**OFFICE OF THE SECRETARY  
CORRESPONDENCE CONTROL TICKET**

SUBJECT: Thermal hydraulic phenomena

Subject: Information - Written Comments

# **CALCULATION OF HYDROGEN AND OXYGEN UPTAKE IN FUEL ROD CLADDING DURING SEVERE ACCIDENTS USING THE INTEGRAL DIFFUSION METHOD**

17. Comparison of calculated and measured cladding temperatures for NRU FLHT-5 test at 2.2 m.

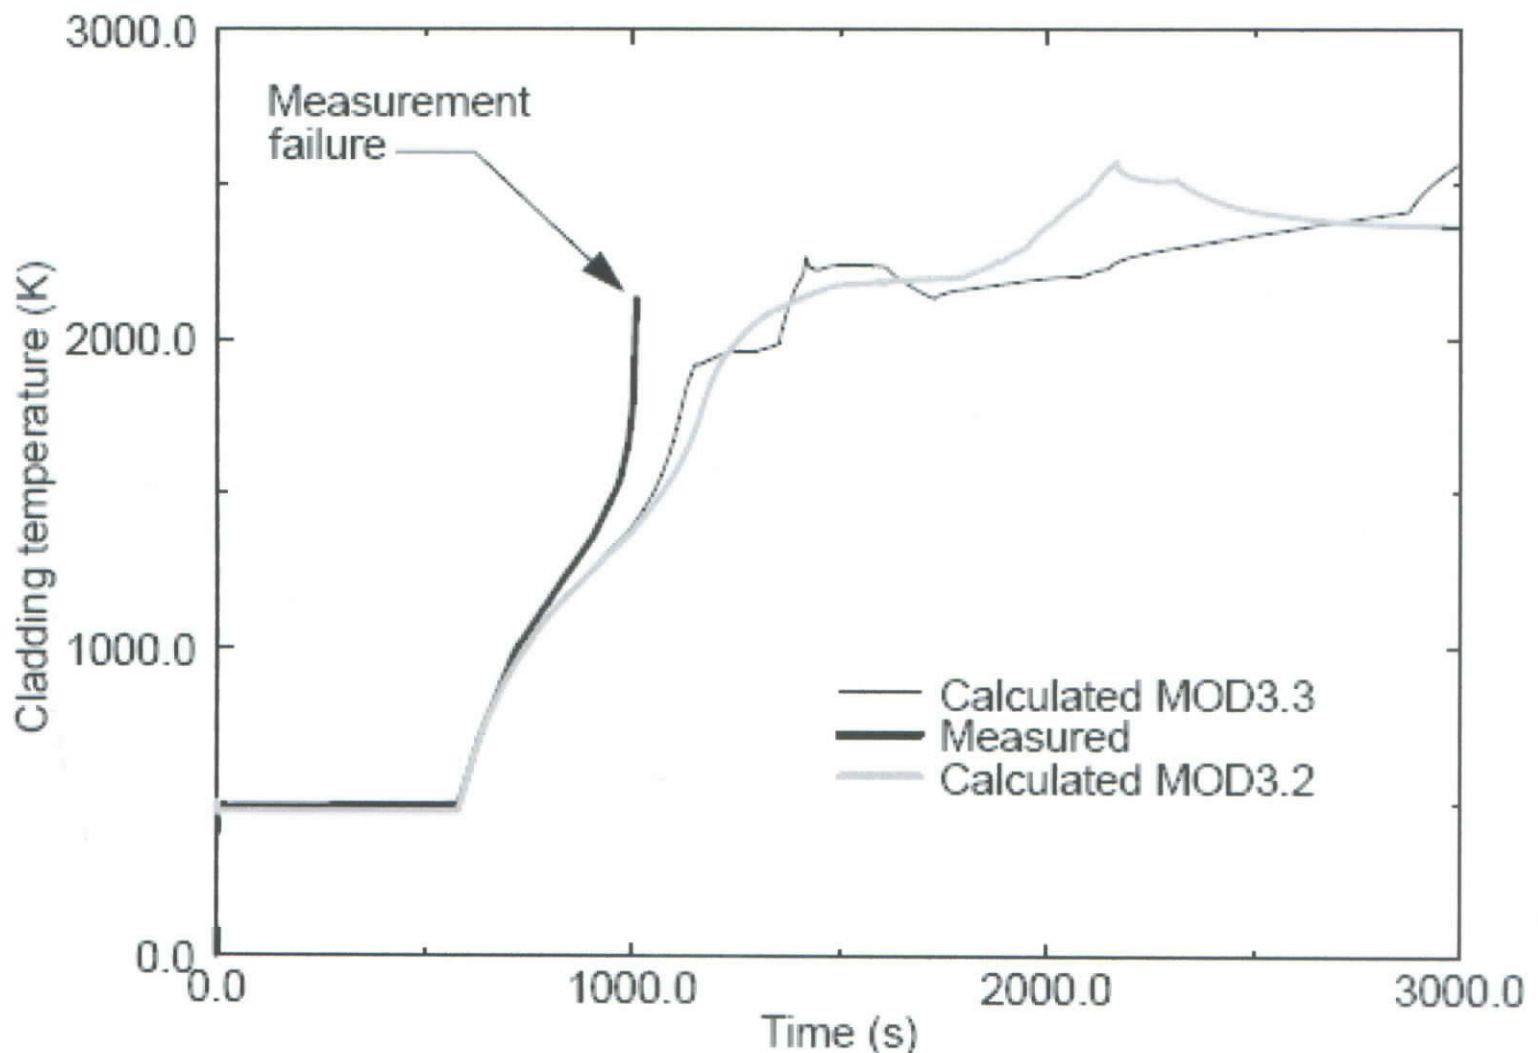
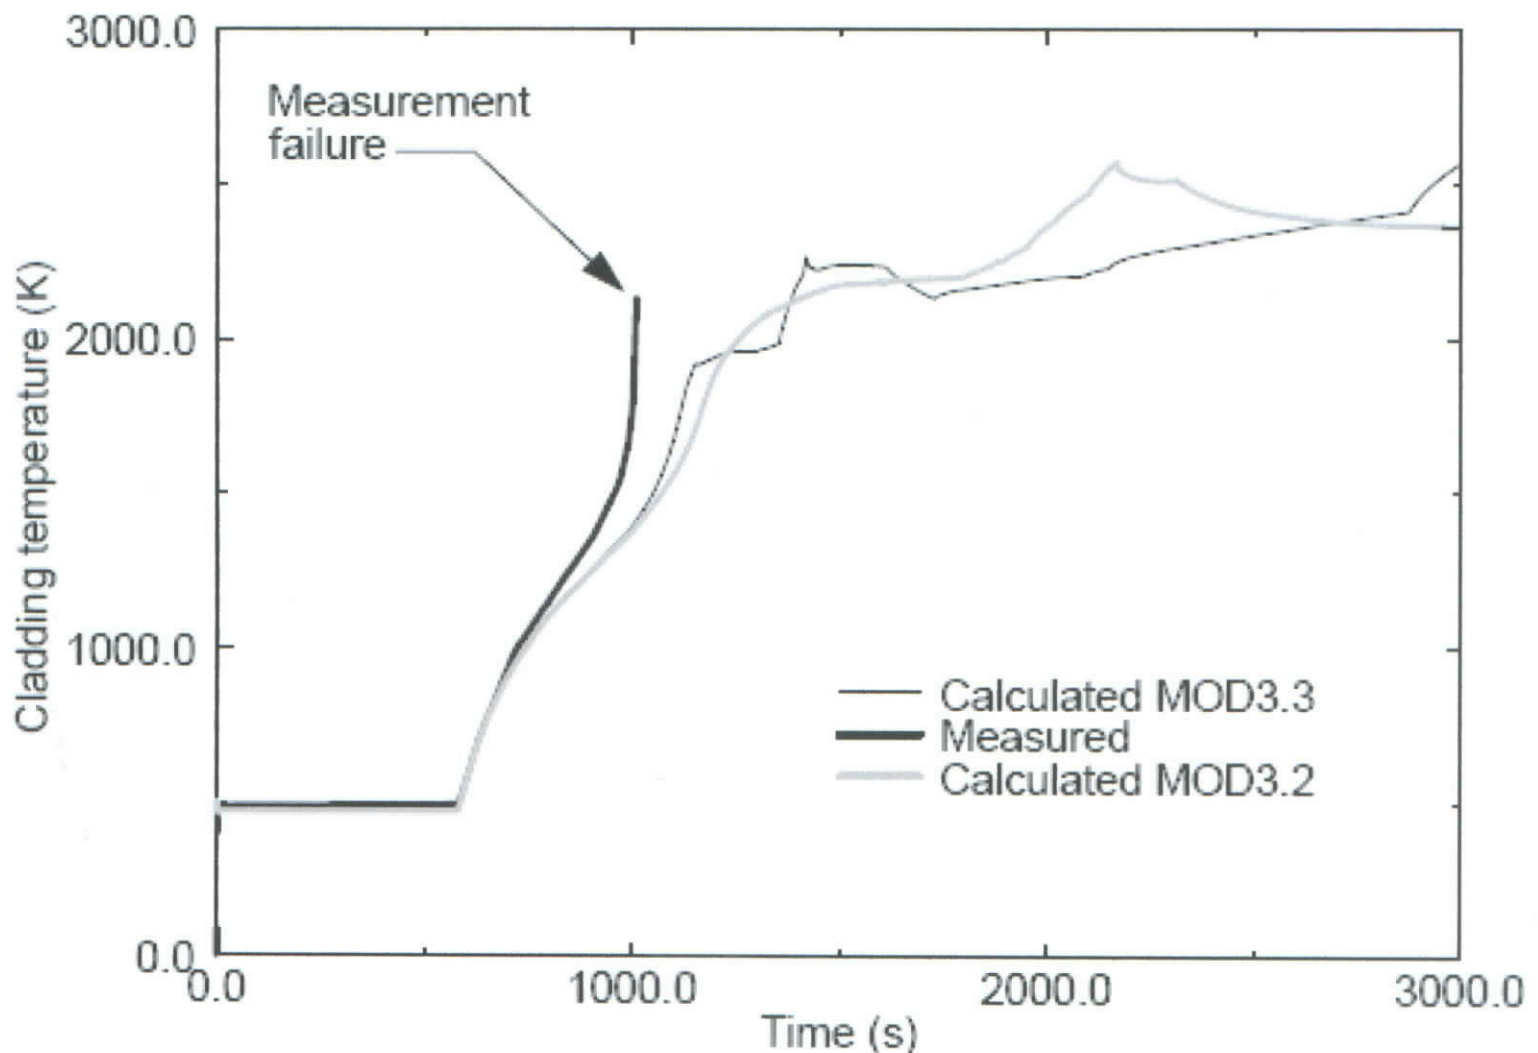
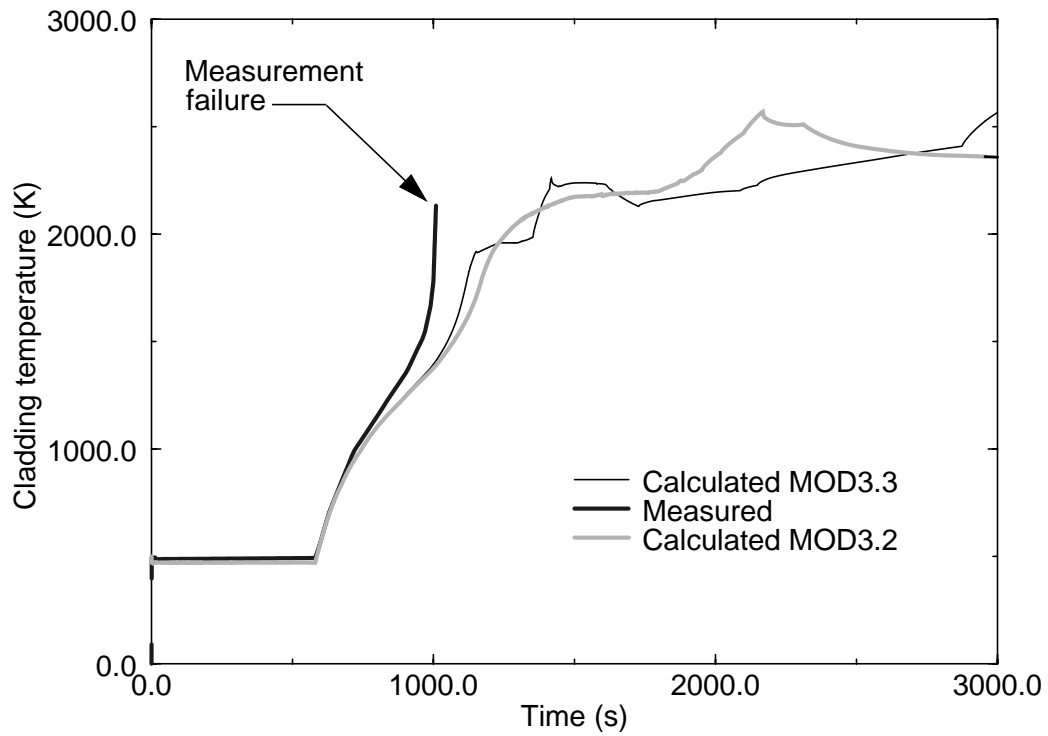
Note that in the region of 1000 K and beyond, the calculated rate of increase of the cladding temperature becomes progressively less than the measured increase. That is because the calculations are based on correlations for the characteristic of the zircaloy steam reaction that are not applicable to the NRU FLHT-5 test. The NRU test was with a multirod assembly. The correlation that was used in the calculations is based on single rod tests. The NRC has not recognized that investigations that involve heating of single specimens of zirconium alloys in steam do not yield applicable data for the temperature or range of temperatures at which thermal runaway is initiated in LWRs.

Note that in the region of 1000 K and beyond, the calculated rate of increase of the cladding temperature becomes progressively less than the measured increase. That is because the calculations are based on correlations for the characteristic of the zircaloy steam reaction that are not applicable to the NRU FLHT-5 test. The NRU test was with a multirod assembly. The correlation that was used in the calculations is based on single rod tests. The NRC has not recognized that investigations that involve heating of single specimens of zirconium alloys in steam do not yield applicable data for the temperature or range of temperatures at which thermal runaway is initiated in LWRs.
